LEGACY CHURCH - GREEN MOUNTAIN FALLS, CO DEVELOPMENT PLAN

COVER SHEET
SHEET 1 OF 13

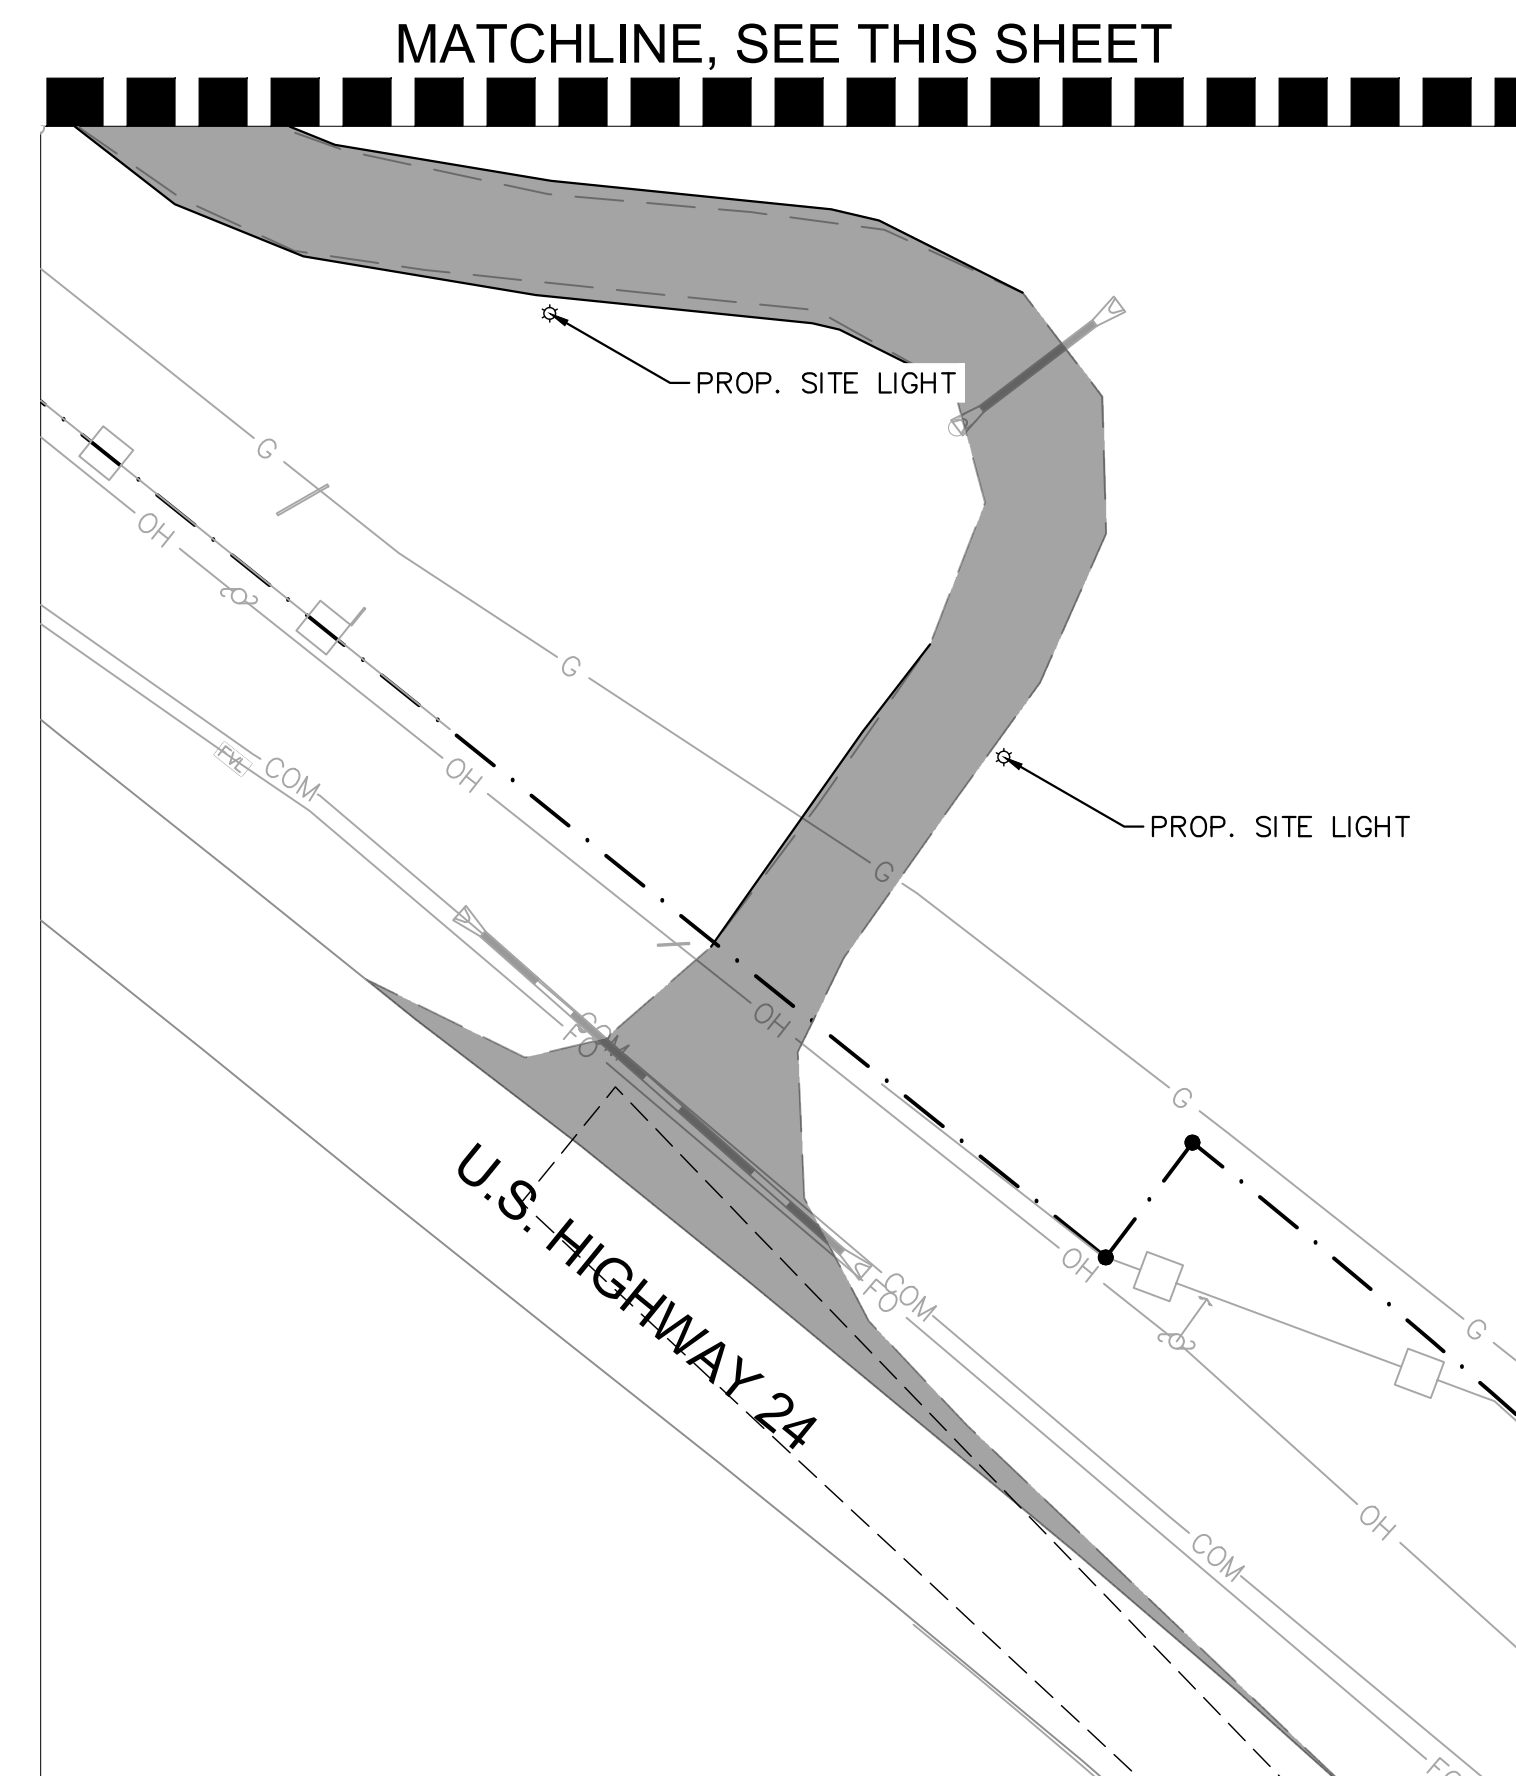
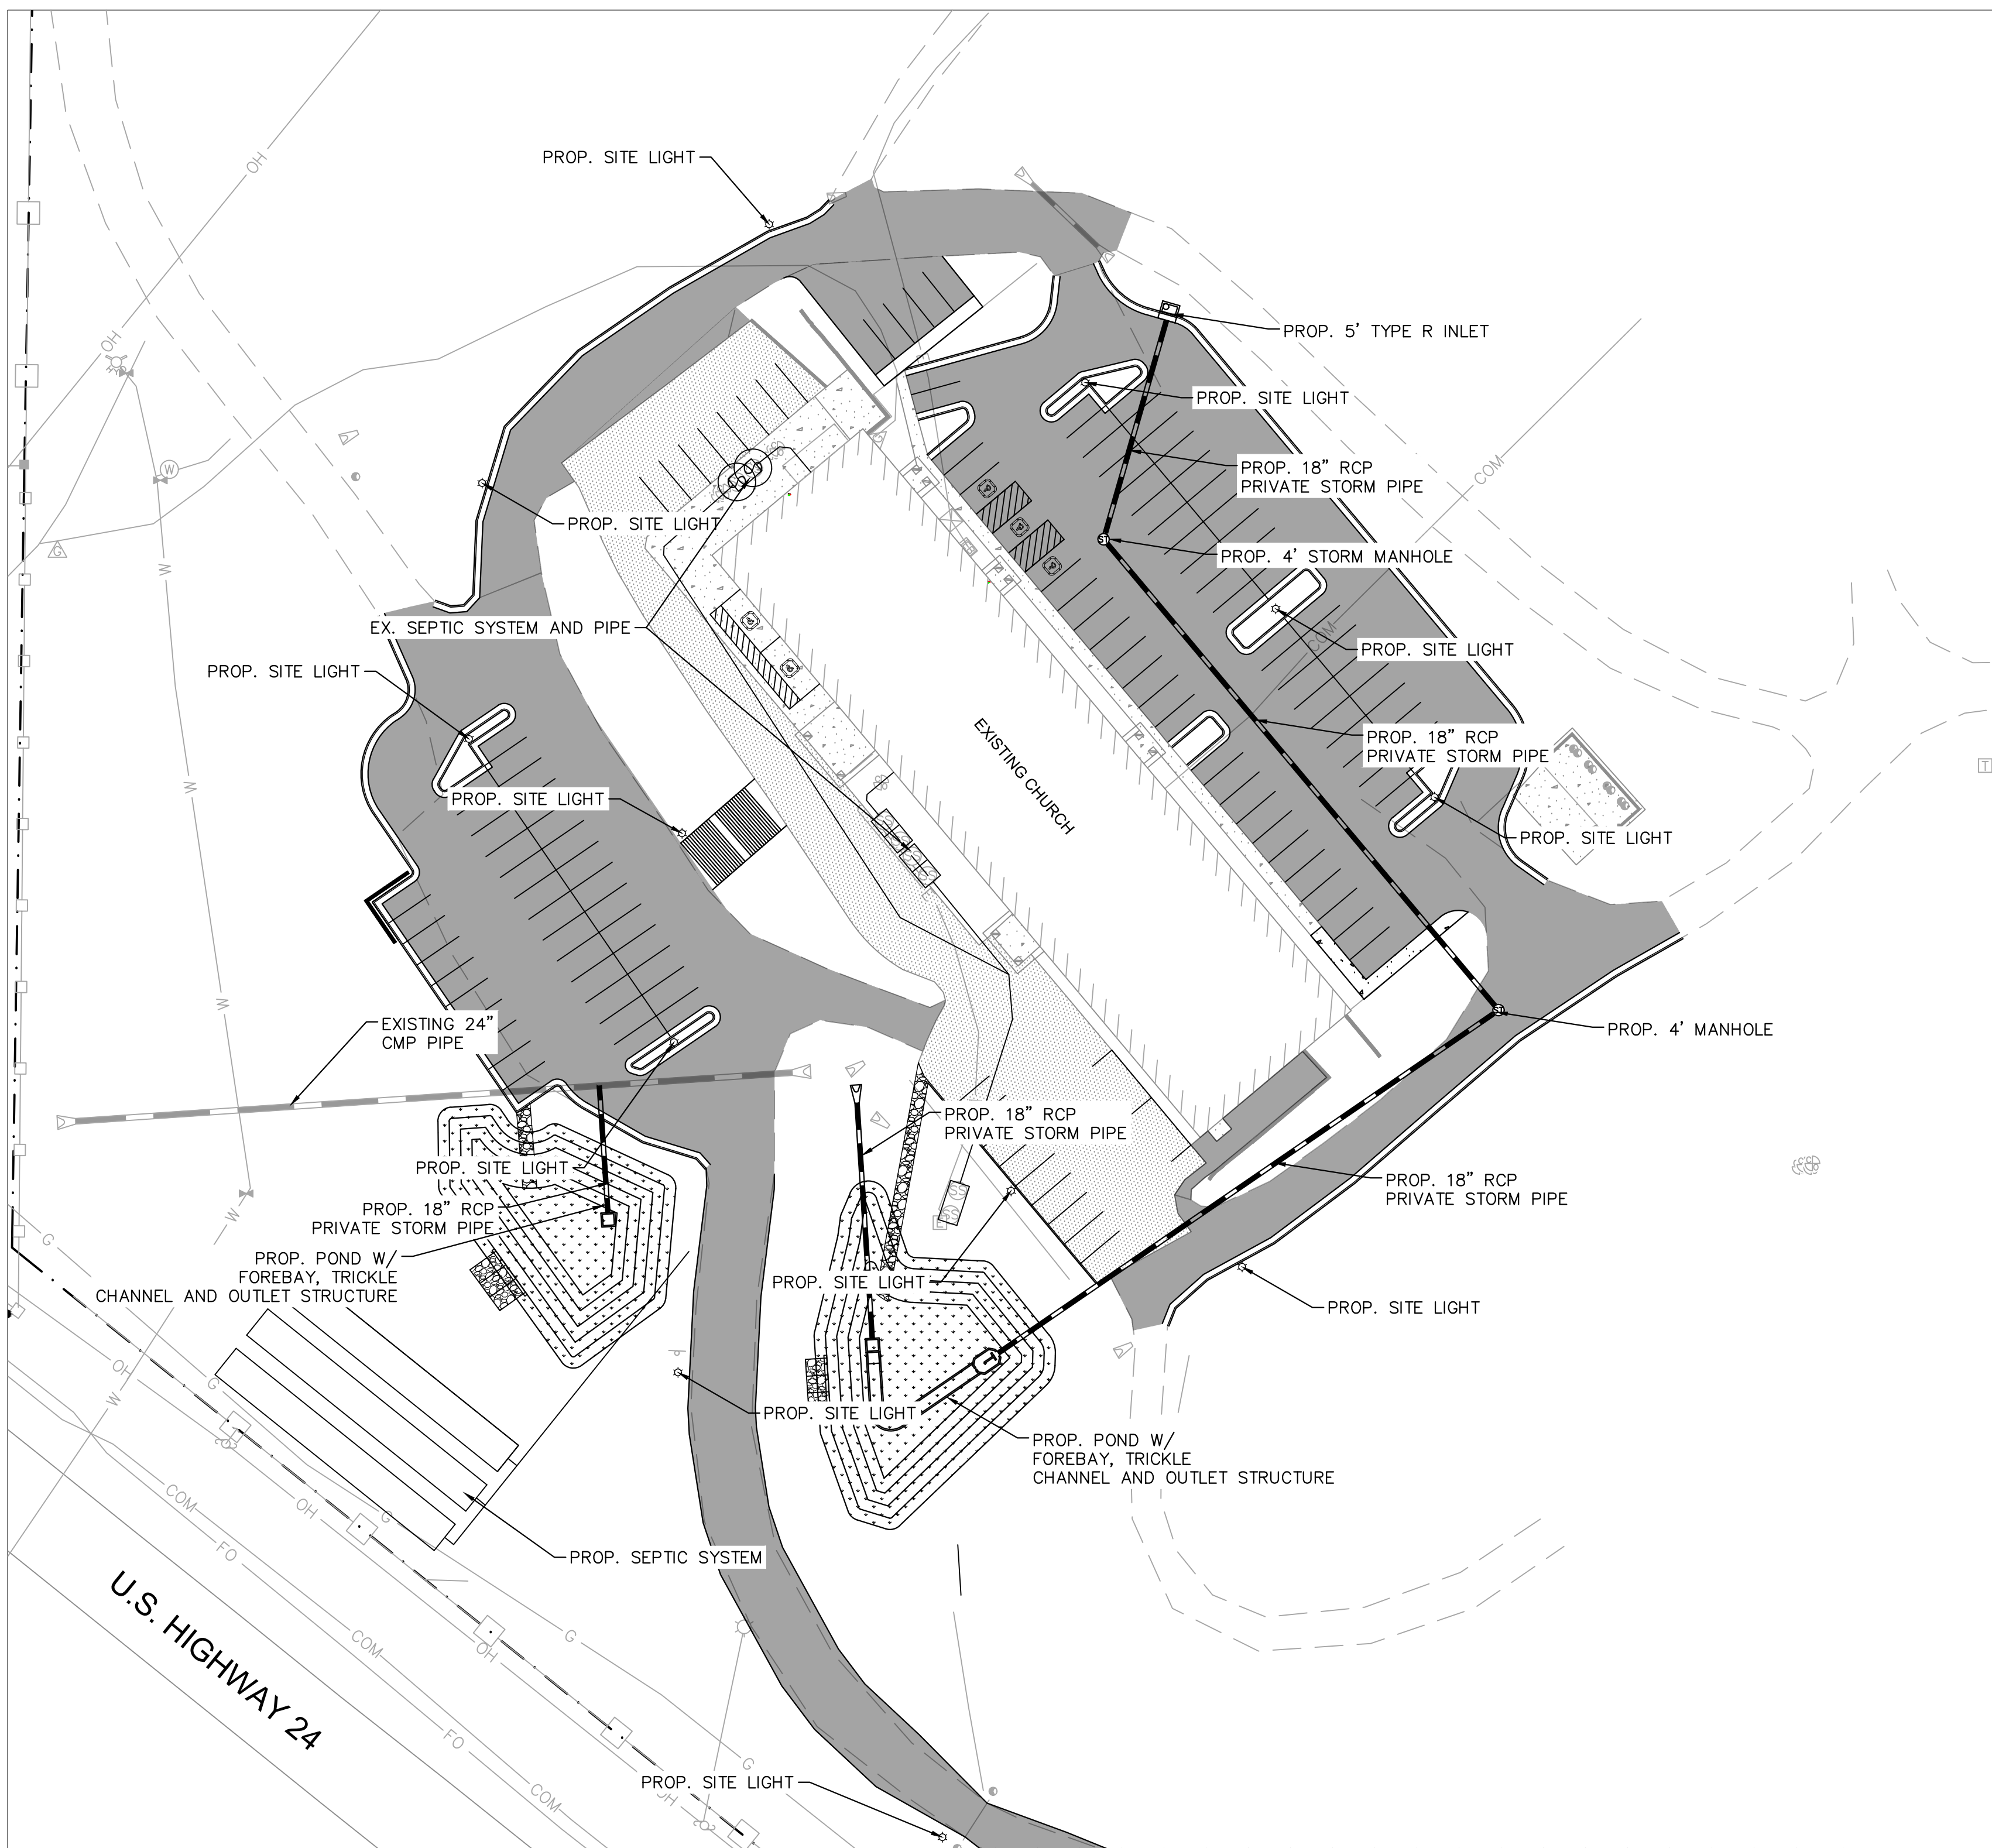
The traffic study indicates that deceleration and acceleration lanes are required. Please show the line work of the proposed lanes. A call-out may be added to refer to construction plans submitted to CDOT.

Once construction plans/access permit has been approved by CDOT, staff asks that the CDOT approved documents be uploaded for our records.

Please add the following note:
 The parties responsible for this plan have familiarized themselves with all current accessibility criteria and specifications and the proposed plan reflects all site elements required by the applicable ADA design standards and guidelines as published by the United States Department of Justice. Approval of this plan by El Paso County does not assure compliance with the ADA or any regulations or guidelines enacted or promulgated under or with respect to such laws.

ISSUED: 7/19/19
UTILITY SHEET
SHEET 4 OF 13

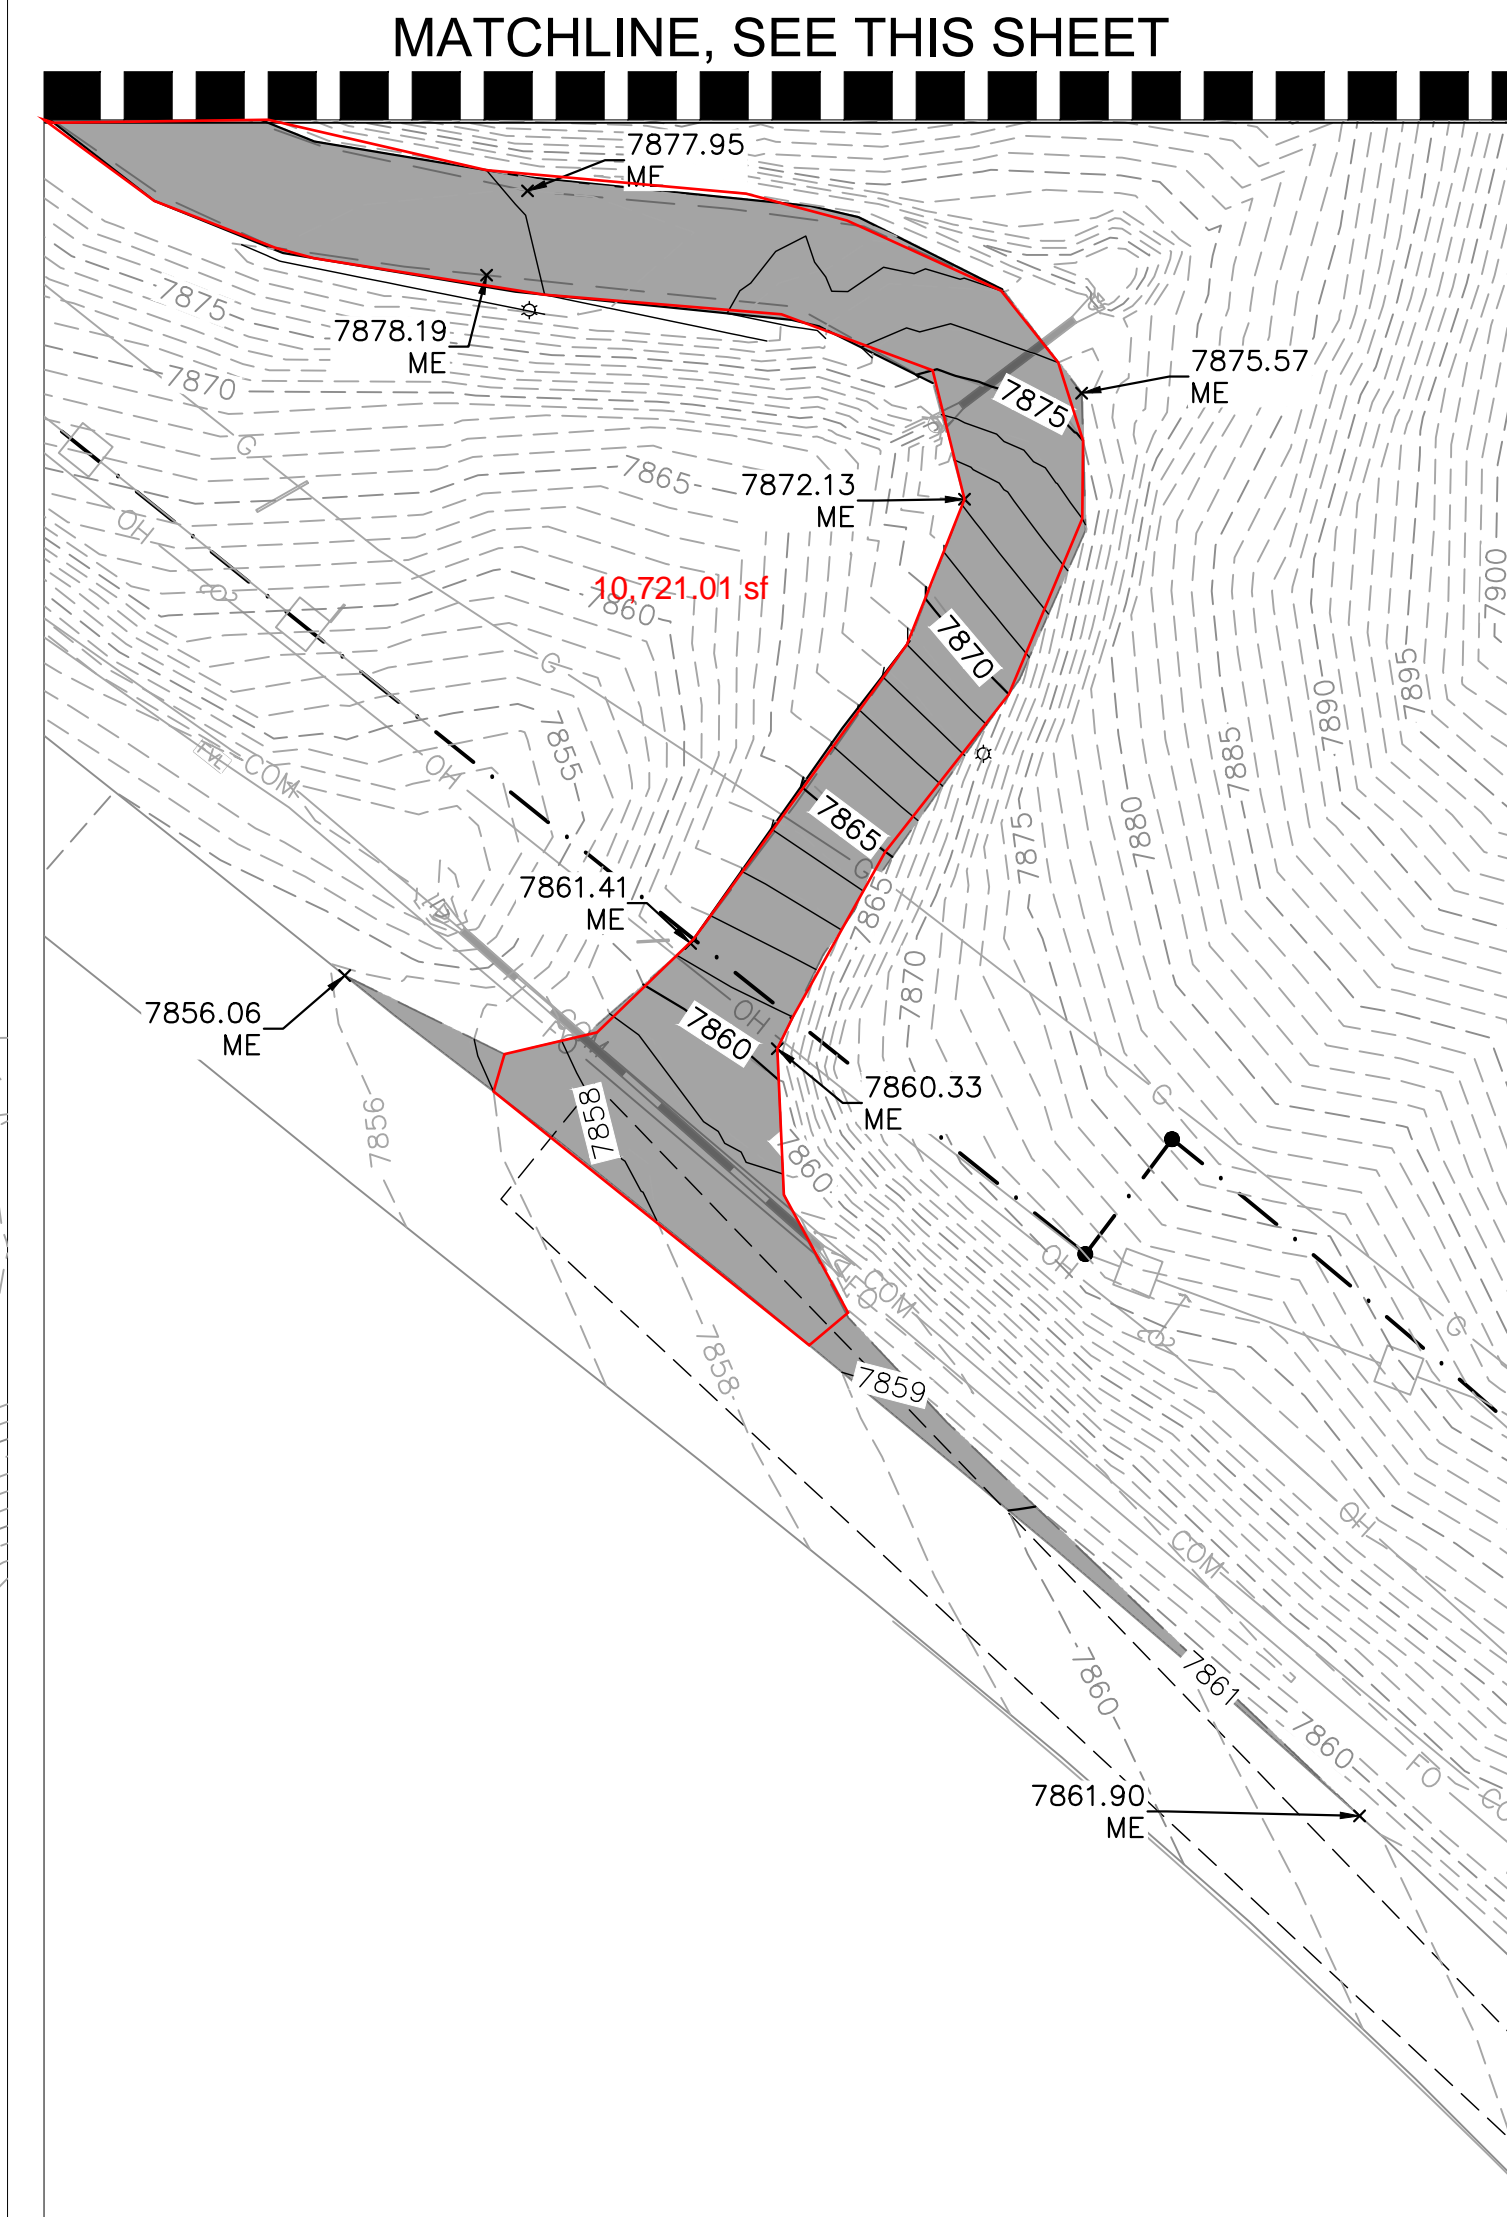
Parking information does not match what is shown on the previous page. Revise accordingly.
